# 1.0 Introduction

Following improved access to the rear of 26 Denmark Street and the East Gable of 22 Denmark Place, we have identified a number of discovery item issues that are addressed in the corresponding application drawings as well as summarised within this document.

## 26 Denmark Street

Reference image: LHS – 9 & 10 Denmark Street Roof Tile. RHS – Proposed Clay Roof Tile

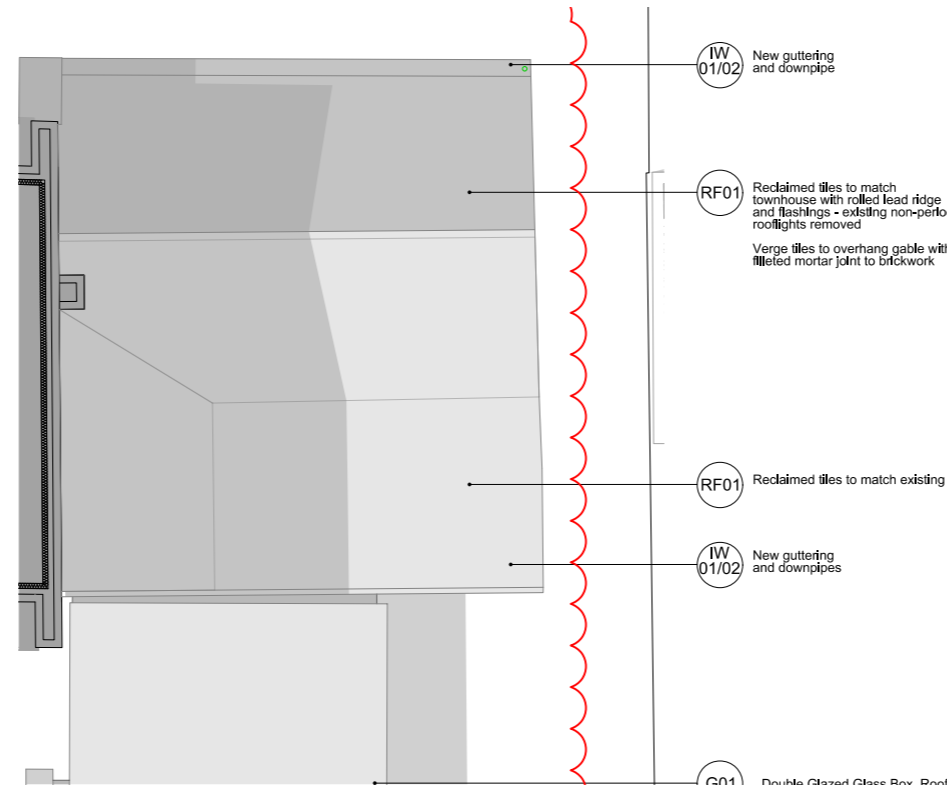
Following review of the existing slate roof tiles, many of which are damaged and/or coated with bituminous paint with a large quantity requiring replacement.

As can be seen from the image the existing roof tiles are generally in poor condition and the removal and re-hanging will cause further damage to the slates.

The condition and extent of replacement slate tiles gives us the opportunity to provide period appropriate tiles, such as the red clay tiles that have been installed on 6,7,9 & 10 Denmark Street. Please refer to reference images below.

We propose to re-tile the existing roof with red clay tiles to match 6, 7, 9 & 10 Denmark Street. The change from slates to more authentic tiles will better reveal the significance of the listed building. This change will also benefit and enhance the street scape by providing more consistency and unity of roofing finishes along Denmark Street.

The specification of the tile is proposed to match the installed tiles on Denmark Street South. The tiles that have been used are Clay Hall Medium Blend by Heritage Clay Tiles Ltd.

Consented Roof Plan Extract

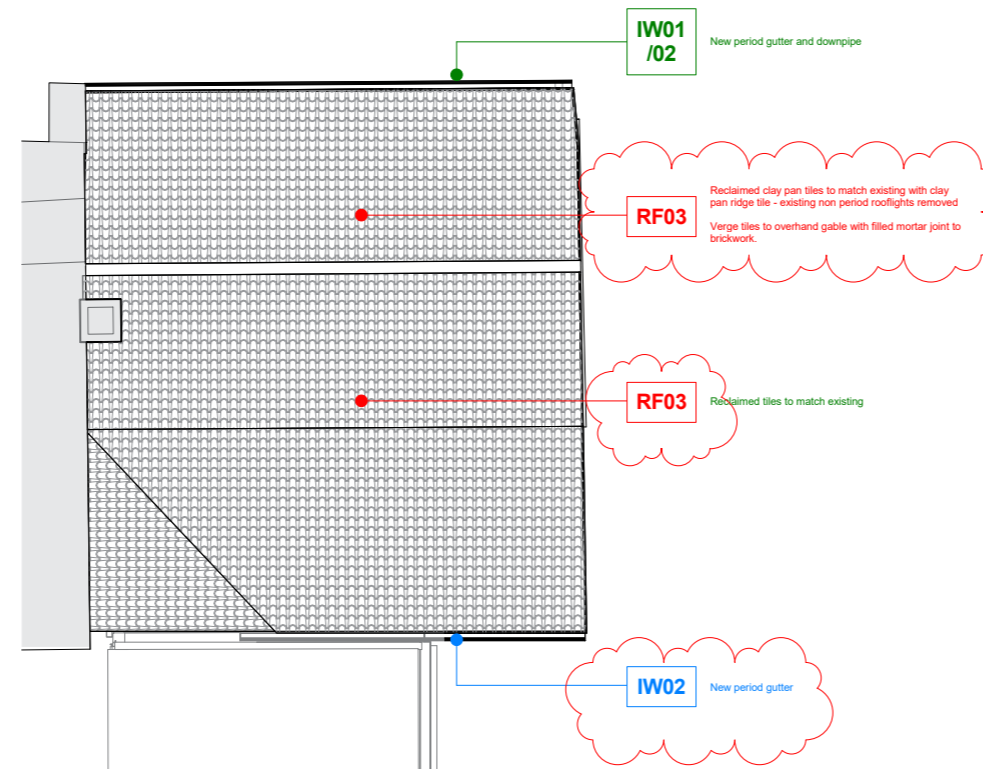
Following the consented removal of the existing roof finishes, it was revealed that the existing roof tiles were not slate but a red clay pan tile.

In response to this and the proposed works to 26 Denmark Street we propose to match the existing red clay pan tiles for like for like replacements.

This has been discussed with ABA, and deemed a sensitive response to the existing building, as slates would not have been originally installed on a building of this age.

The tiles will be tonally similar to the proposed tiles to 26 Denmark Street
